EL PASO COUNTY PLANNING AND COMMUNITY DEVELOPMENT DEPARTMENT

PRELIMINARY DRAINAGE REPORT (PDR) CHECKLIST

Preliminary Drainage Report

The Shire at Old Ranch
PPR2410

DR -3
Drainage Plan

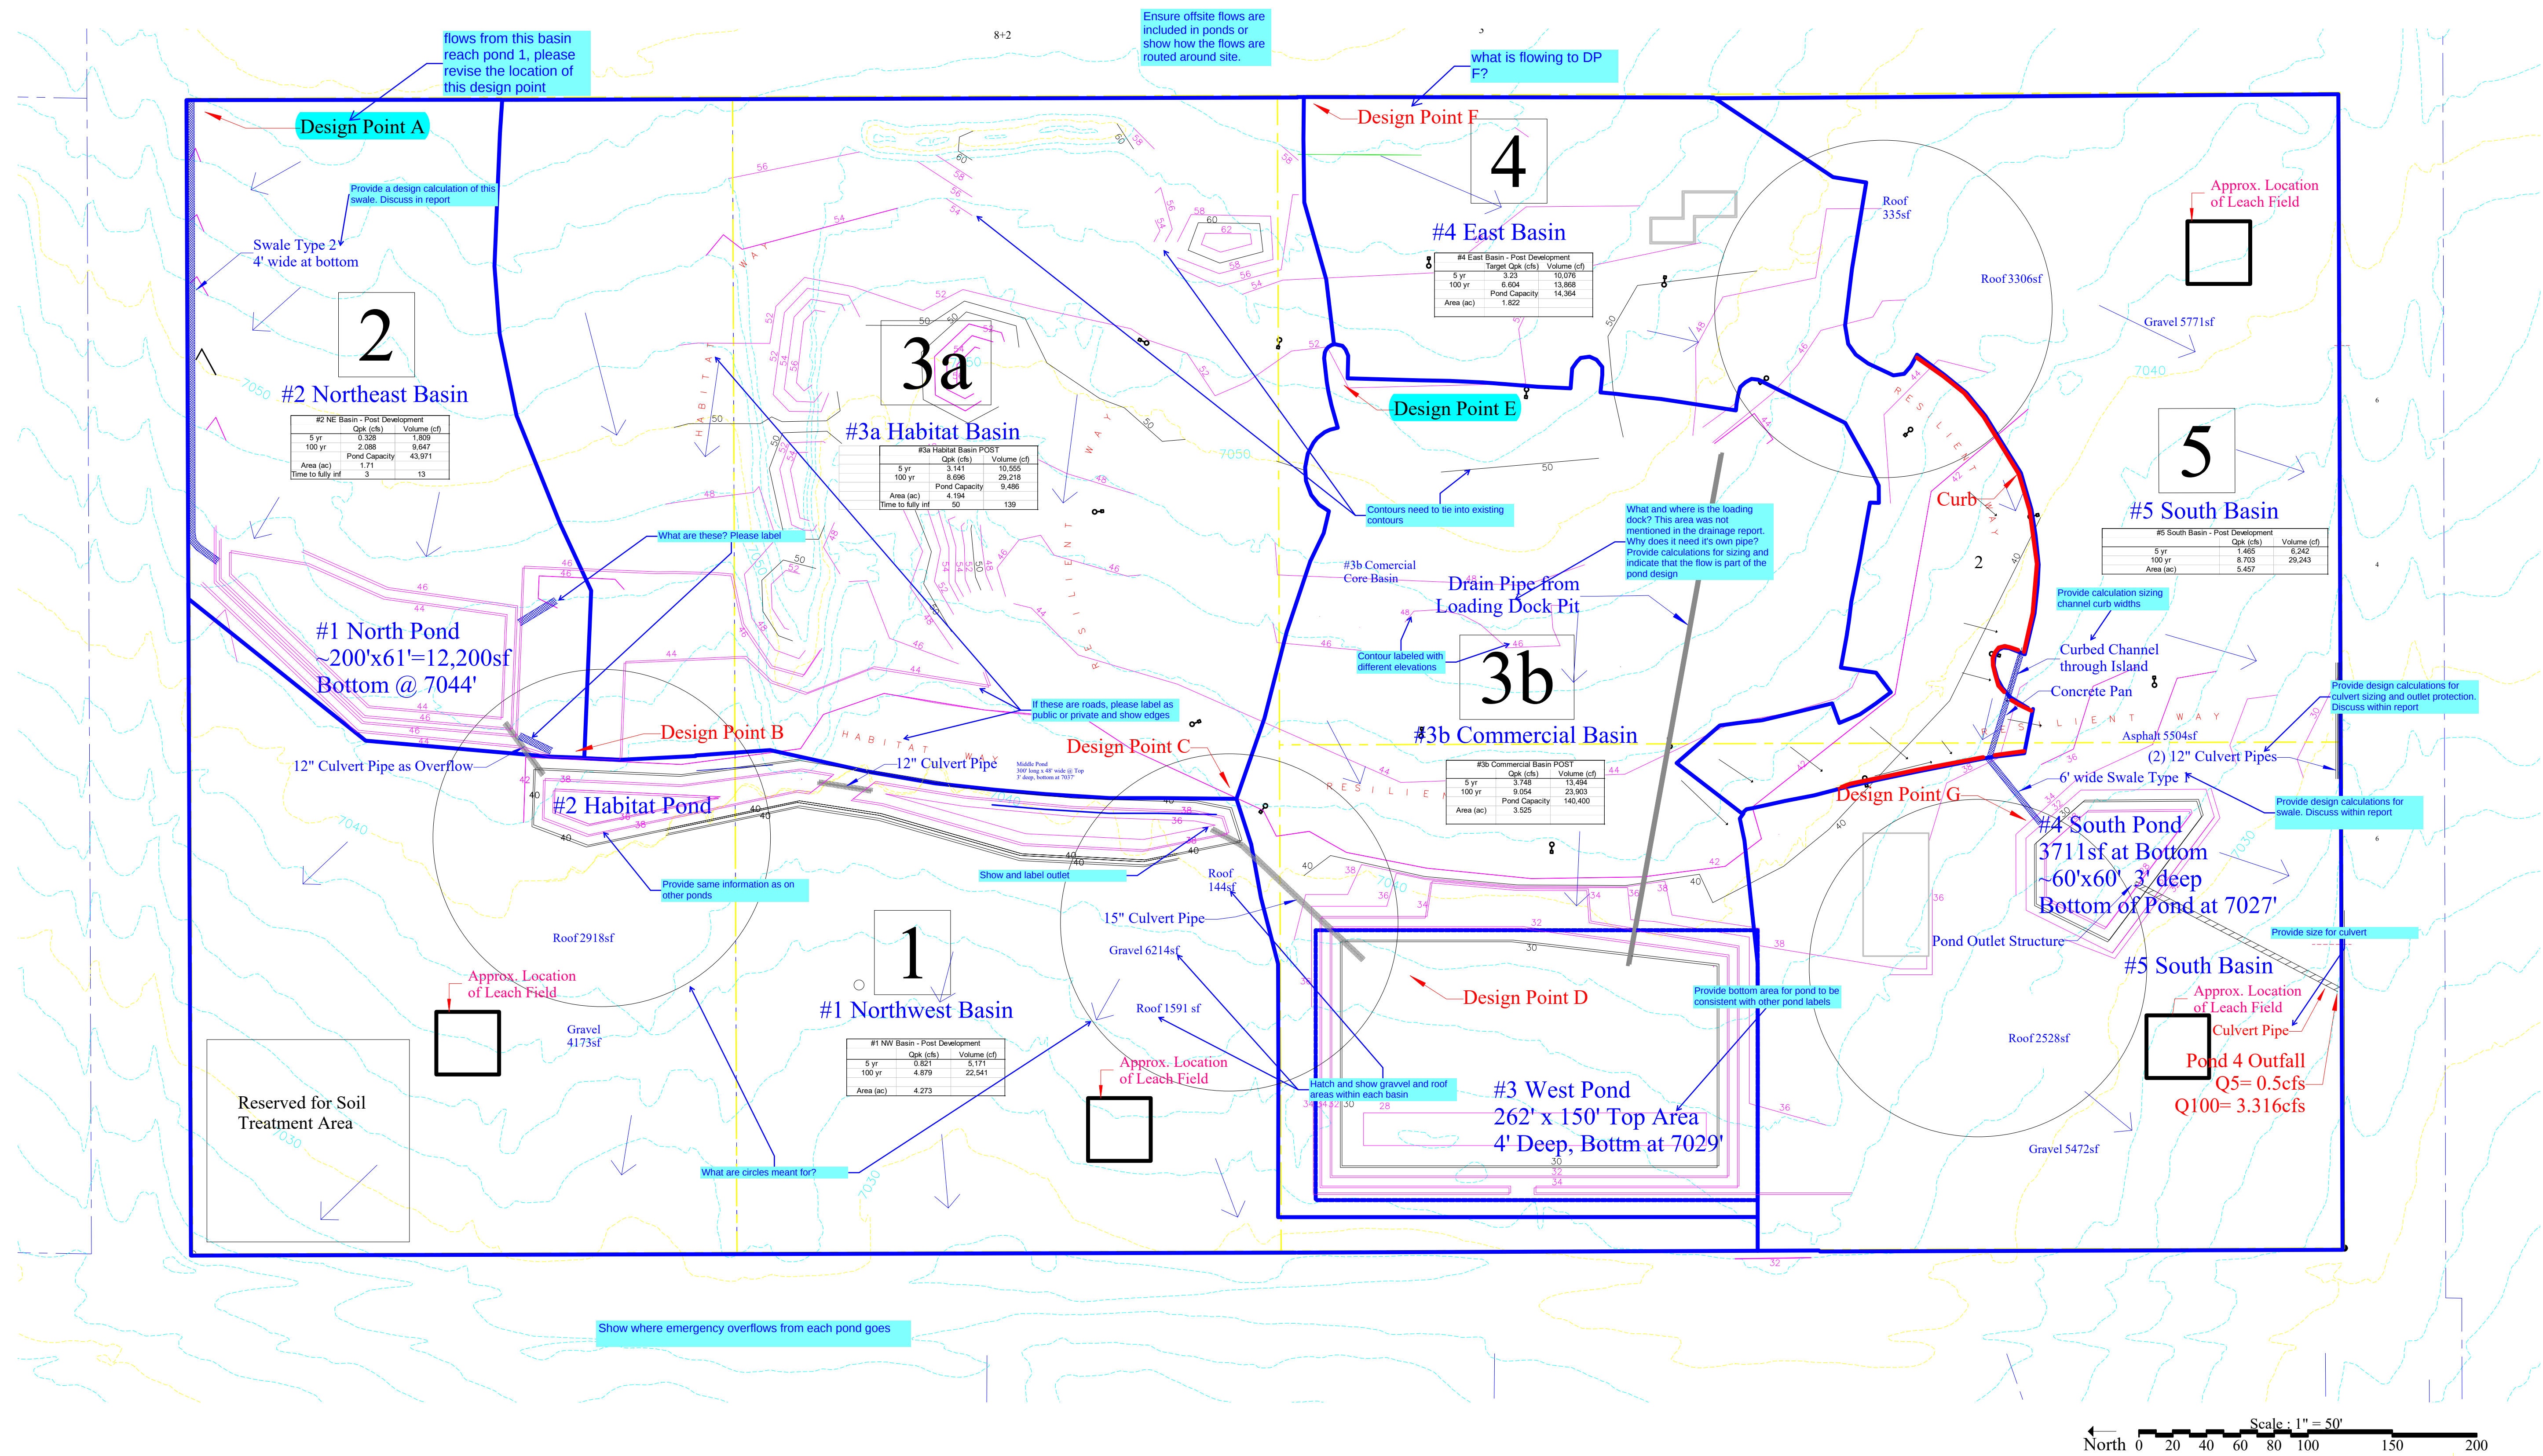
- Provide legend
- Provide design point summary table
- Show and label existing roadside ditches for Howell Road and Old Ranch Road. Provide design calculations for ditches.
- Label existing roads

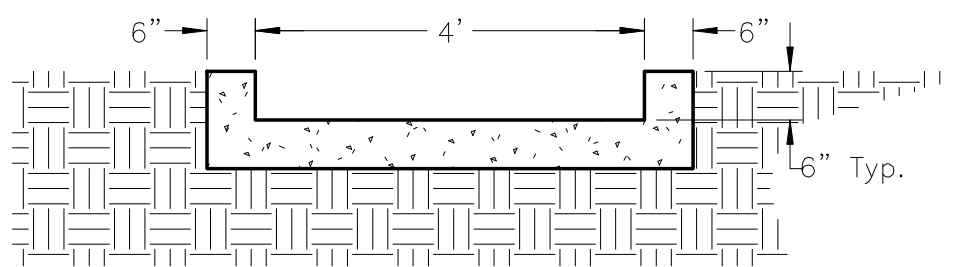
This legend needs to be on the map sheets

Grass and Rock Lined Swale, Typ.

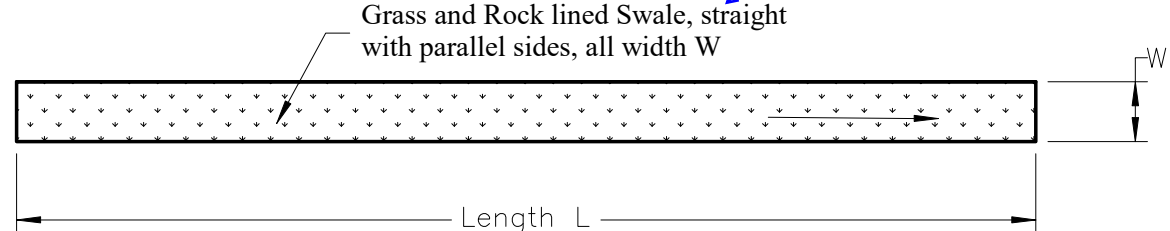
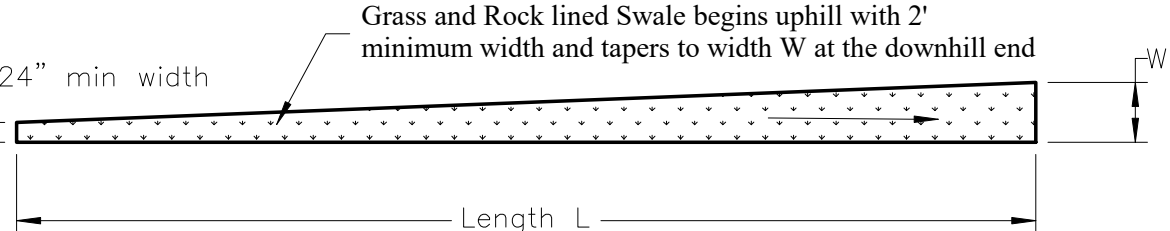
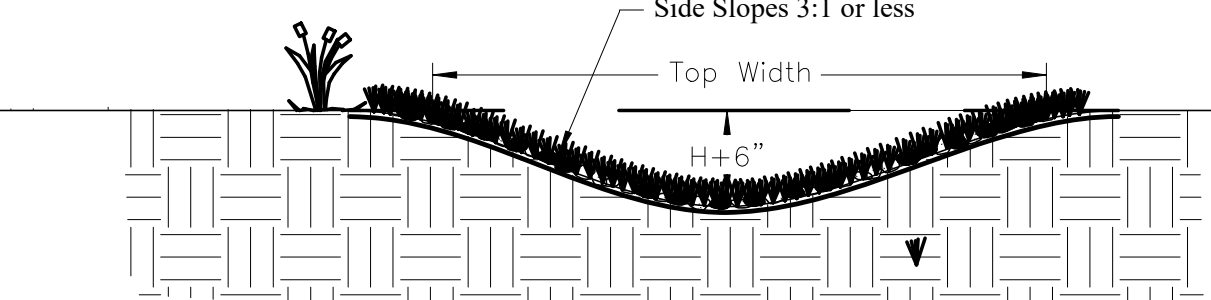
Provide calculations for sizing of riprap. How can depth of riprap be only 4" if size of rocks is up to 5"? Show on the drainage map where these are located on the ponds
